W3F1-2010-0050

**Subject:** Response to Request for Additional Information Associated with  
Technical Specification Table 3.4-1 Isolation Valve Addition  
Waterford Steam Electric Station Unit 3  
Docket No. 50-382  
License No. NPF-38

**Response to Request for Additional Information**

B424  
SHEET E596

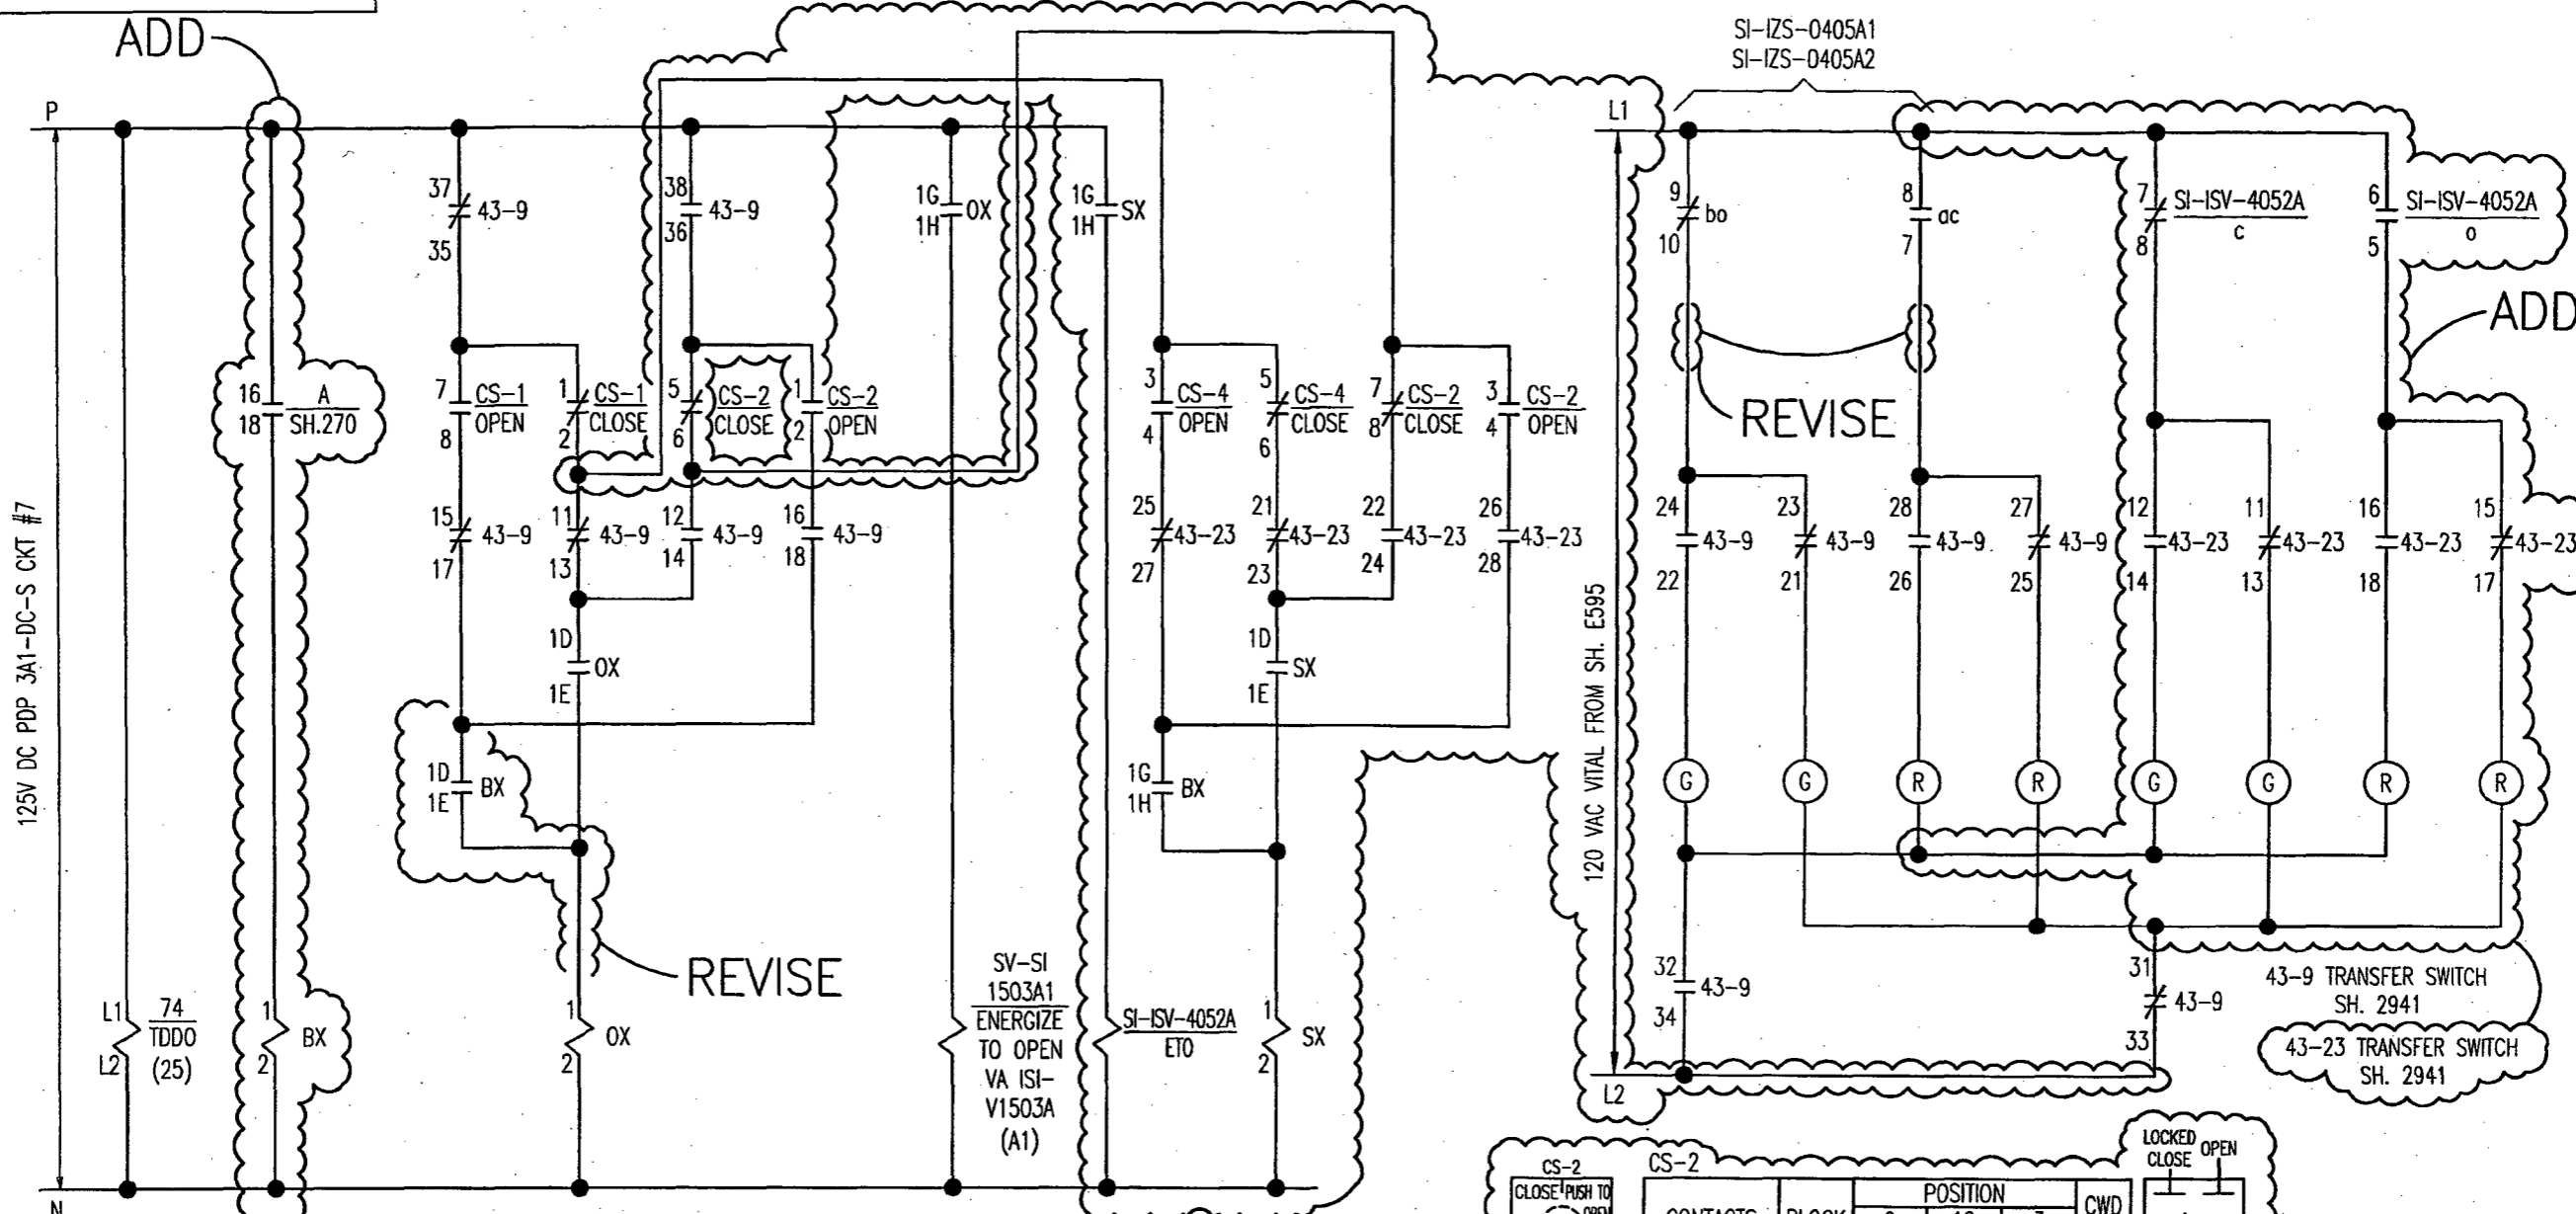
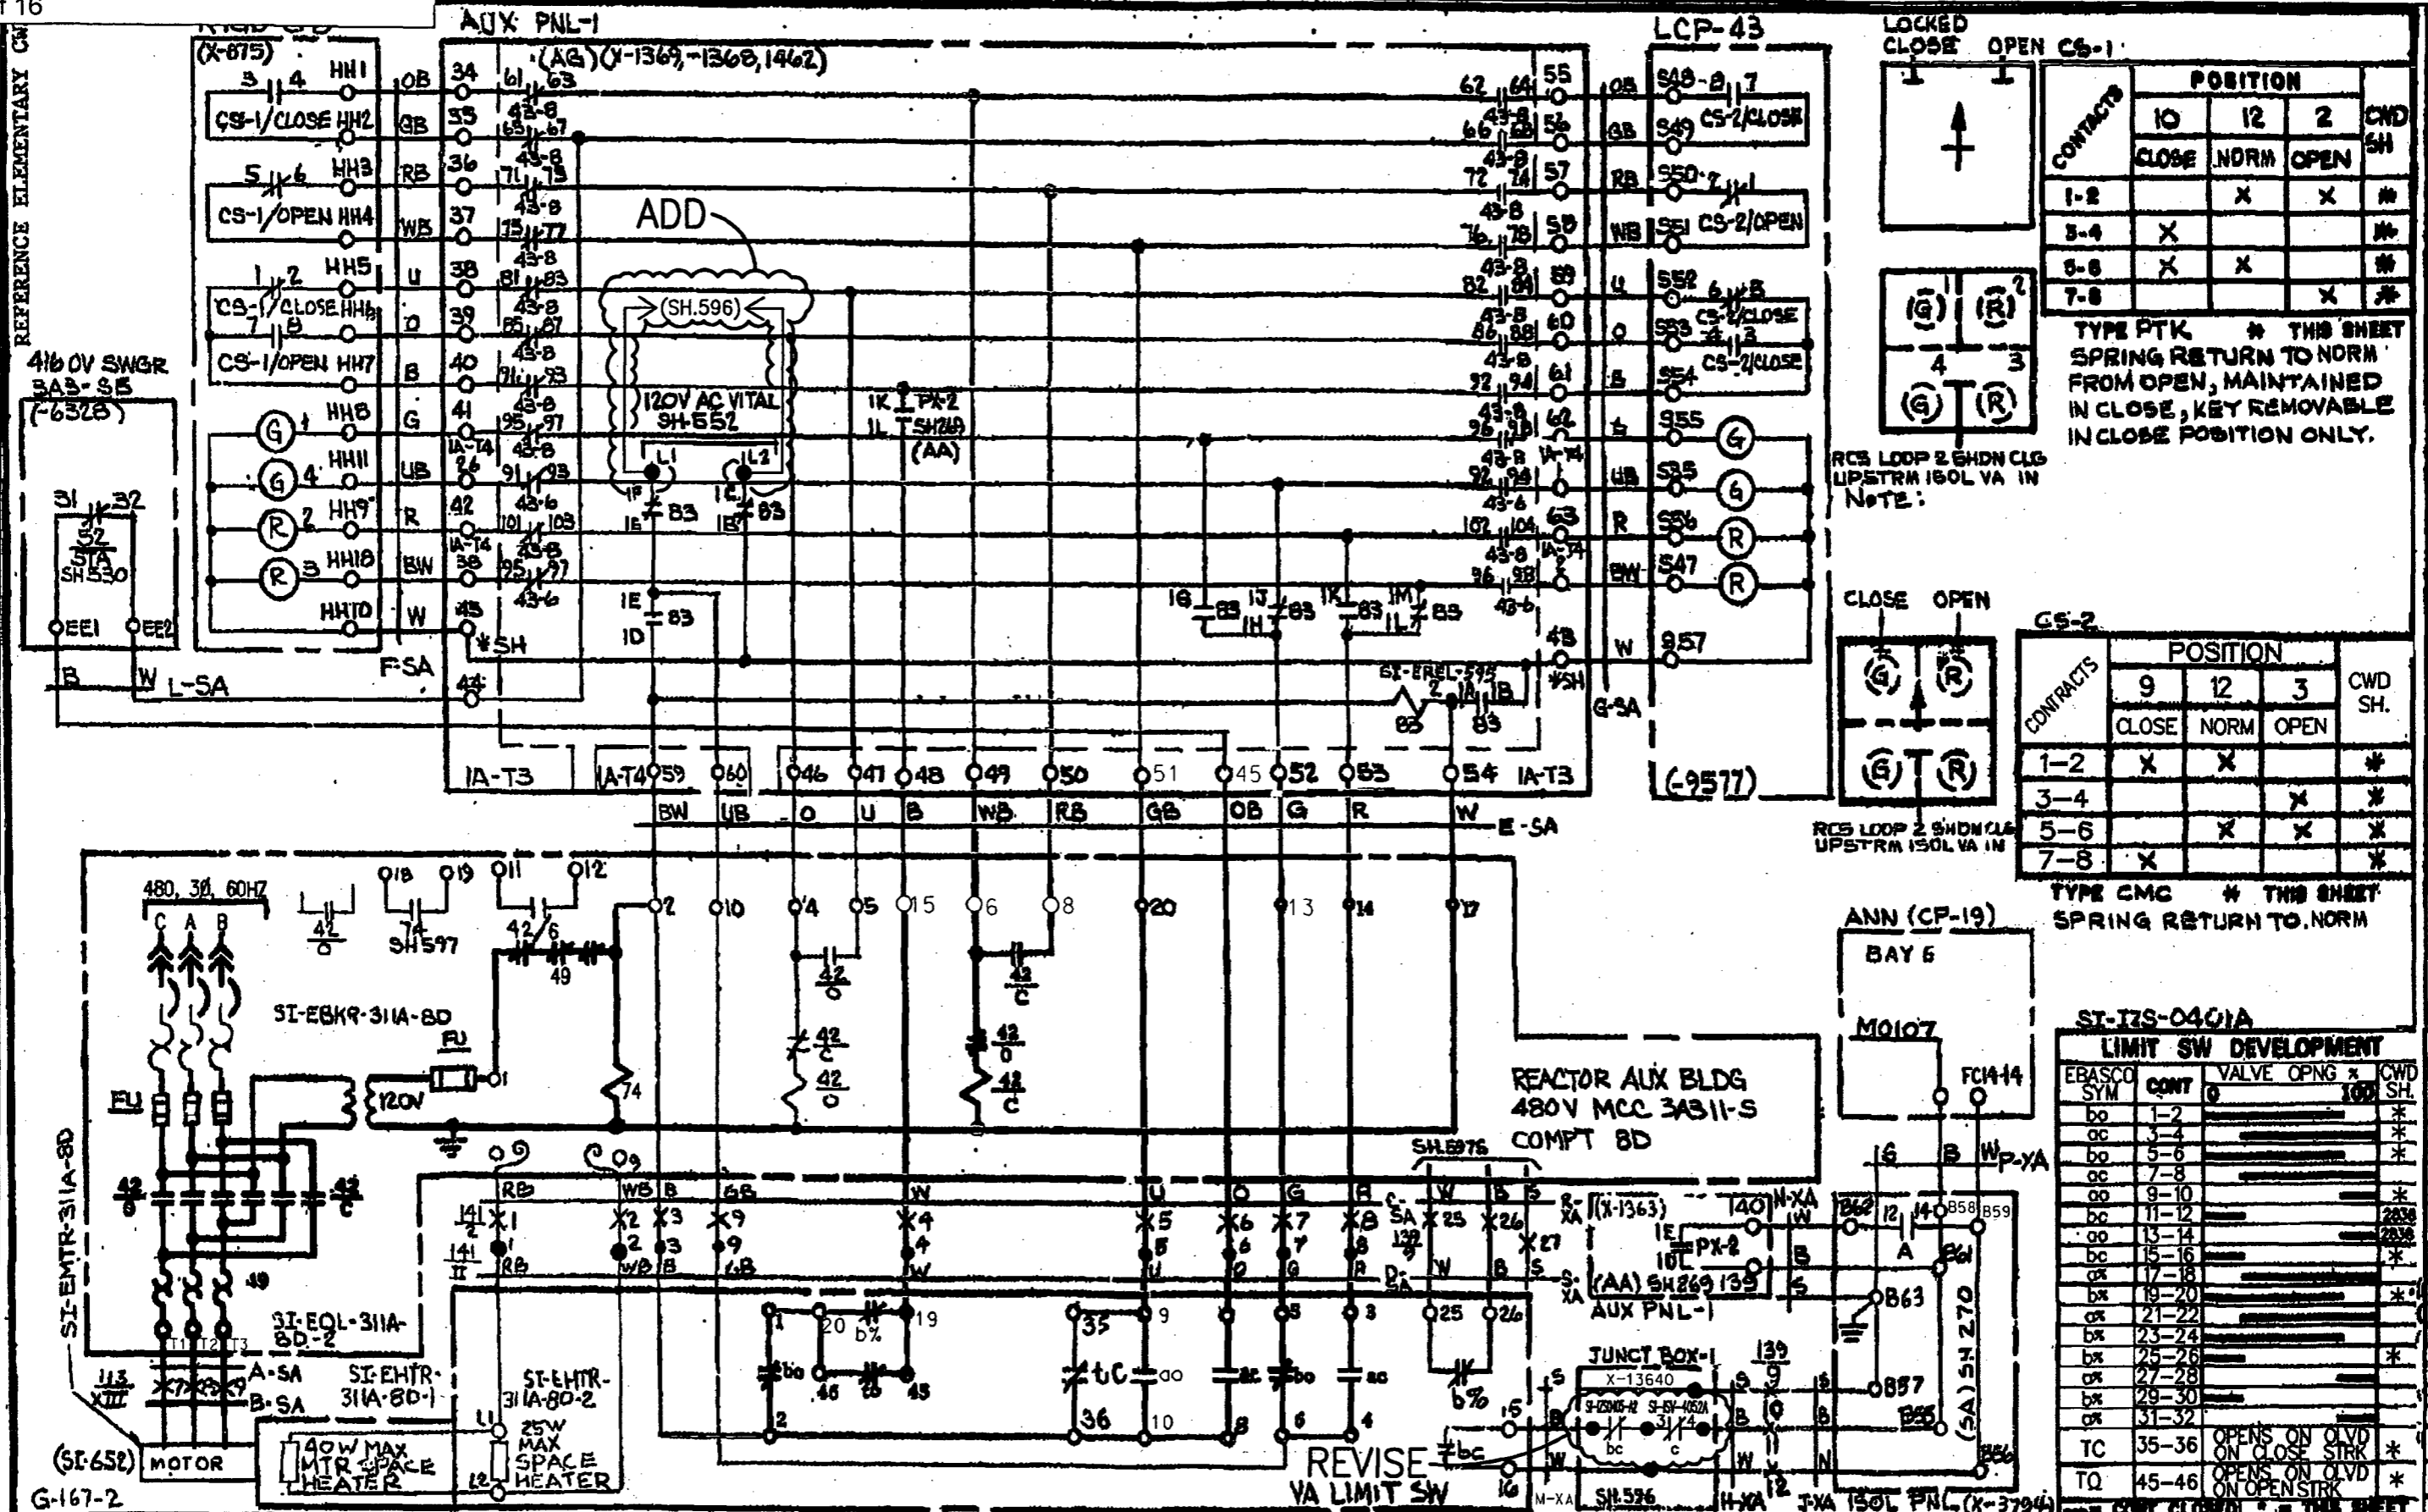
Provide the electrical one line and applicable schematic drawings showing the power and control circuits for valves SI-4052A and SI-4052B.

Drawings B424 Sheets 596, E596, 595, and E595 are the schematic drawings showing the power for valve SI-4052A and its indication lights.
